N1090A-01

Modification Recommended Service Note

N1090A DCA-M Sampling Oscilloscope (Single Optical Channel)

Figure 1 Updated overlay - should say 1.4 Vpp Max

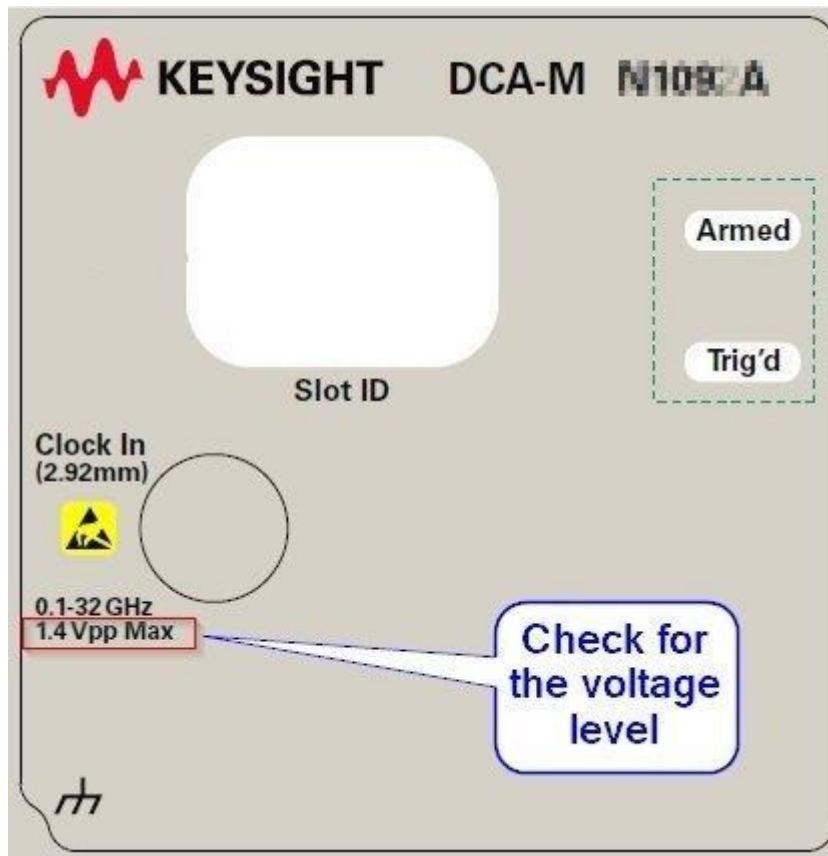
In May 2018, the clock's input port maximum signal voltage changed from 2.0 Vp-p (old value) to 1.4 Vp-p (new value). This is very sensitive circuitry and this change provides additional margin to reduce risk of damage to the instrument.

New instruments shipping after this change has the new left front panel overlay with this updated information, see Figure 1 below.

If the front left panel overlay shows 2 Vp-p (old value), remove the old overlay and replace it with the new overlay that shows 1.4 Vp-p (new value). If the customer has added any asset tags, or other customer information to the old left front panel overlay, it is recommended to send back the old overlay to the customer after it has been removed.
